CITY OF PORTSMOUTH
Department of Public works

Bid # 40-23

Peirce Island Pumphouse and Pool Renovation

ADDENDUM 2

1. Drawing SF501 detail D

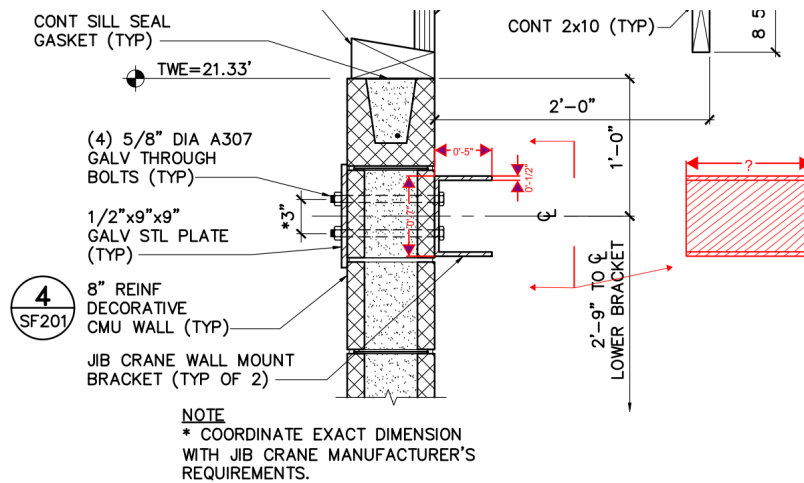
Please confirm the indicated dimension in the attached detail.

A. Brackets are to be a part of the jib crane system and are to be furnished by the jib crane manufacturer. Coordinate bracket size with jib crane manufacturer.”
